SUNDRY NOTICES AND REPORTS ON WELLS

Energen Resources would like to make the following change and add an additional lateral to the Arboles 29 A #11:

Arboles 29 A #11

Side Lateral

WELL LOCATION AND ACREAGE DEDICATION PLAT

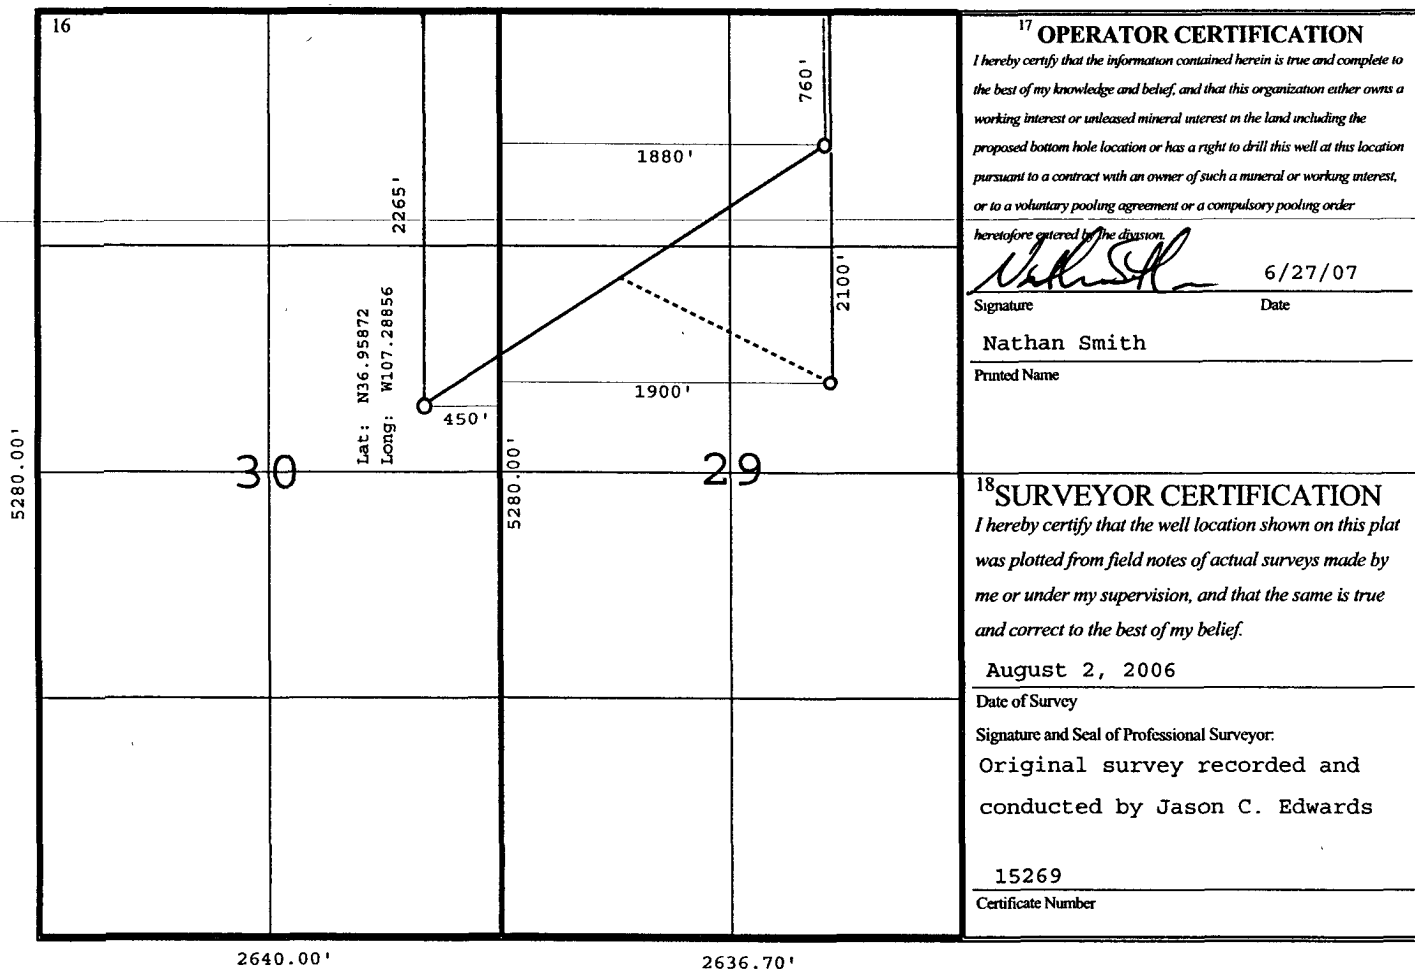
Upon drilling the first or "parent" lateral, an open hole sidetrack will be done at 4930' MD, 3699' TVD and a second 6 1/4" lateral drilled to a TD of 6250' MD, 3699' TVD. The second 6 1/4" lateral will have a bottom hole location of 2100 fnl and 1900 fwl of section 29 as shown in the attached directional wellplan.

Attached is a revised C-102 and a new directional plans.
